Product Change Notice

PCN#: EE-PCN15011M

Shipping box and external and internal label update for Eaton Electronics Division products.

NEW-OUTER CARTON LABEL

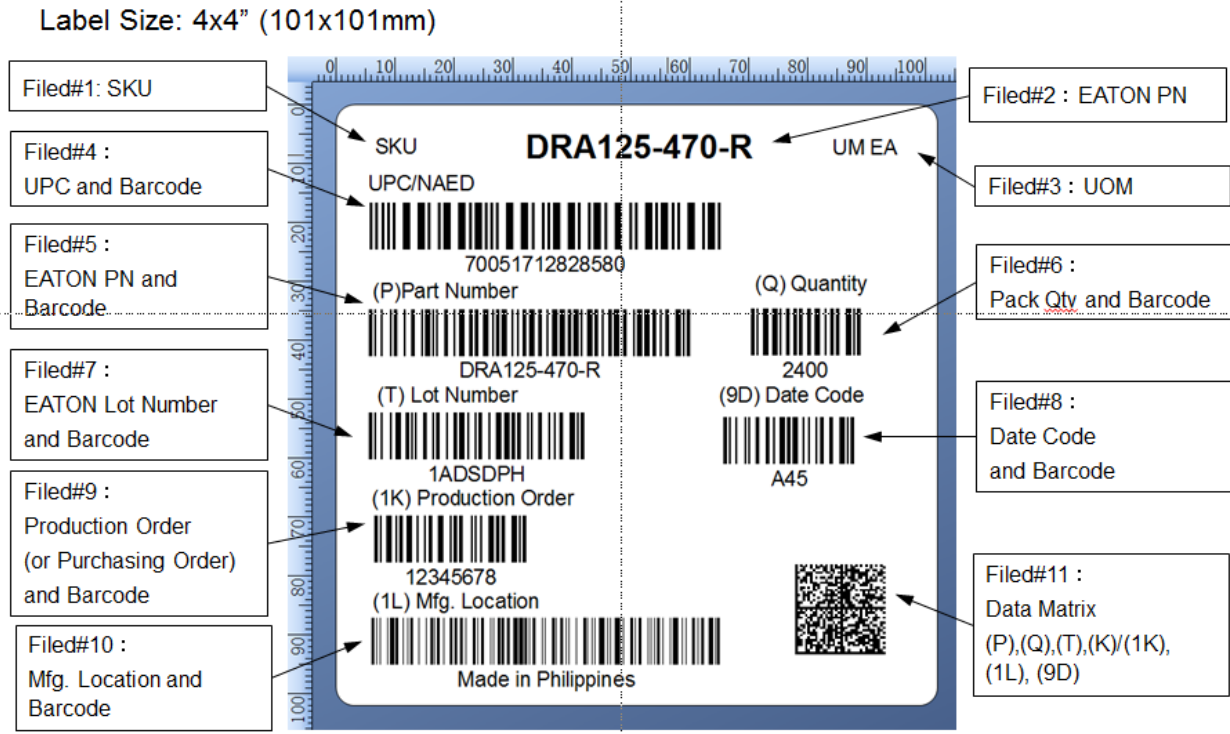
Shipping boxes and labels are being converted from Cooper Bussmann logo to Eaton logo.

Amend: The format of the original Eaton labels has changed---Please see page 3 and 4 for a comparison of the new Eaton labels to the original Eaton labels.

Additional change: The "Lot Number" listed on the outer label is now the "Date Code" reference. Component marking change detail added (See page 5).

(Please note labels shown are examples only and will apply to all Eaton Electronics Division magnetics, supercapacitor, circuit protection and terminal block product)

NEW---INNER CARTON LABEL

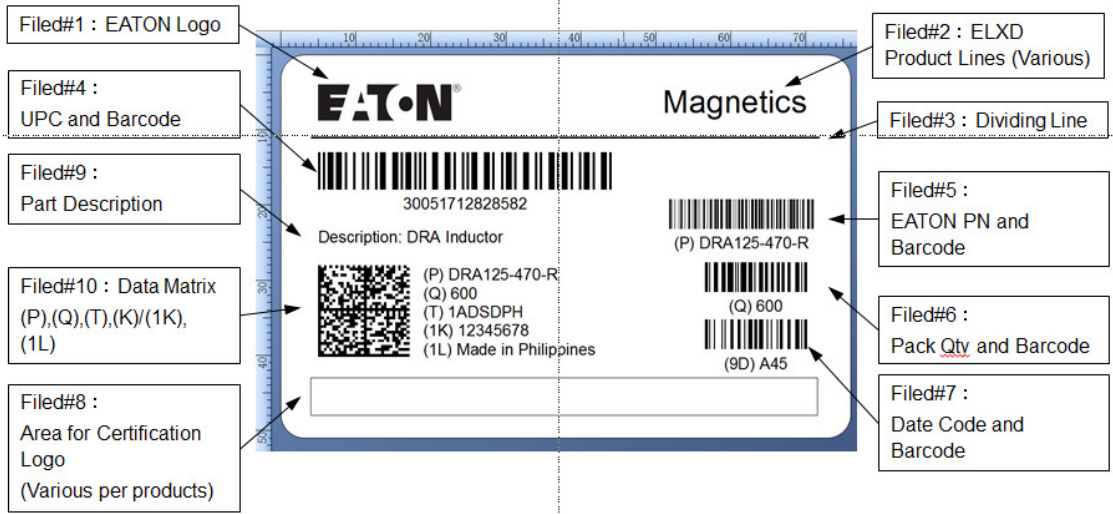
Label Size: 3x2" (76x51mm) preferred.

Optional: 70x36mm, 66x37mm, or other sizes approved by ELXD.

Circuit protection

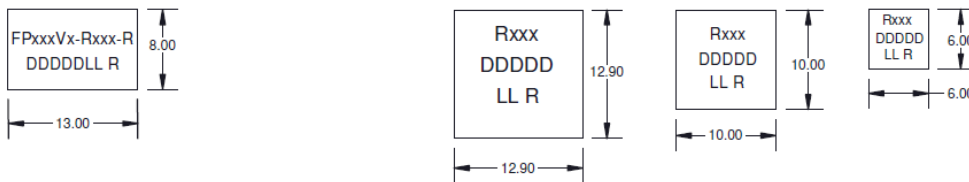
Eaton will be removing the existing date code formats from our product and be replacing the date code with a coded lot code. This is being done to improve traceability, unify format across product lines, and reduce the ability of counterfeit product be sold under the Eaton name. Below is a summary of the changes.

No impact. Date code is not marked on circuit protection product.
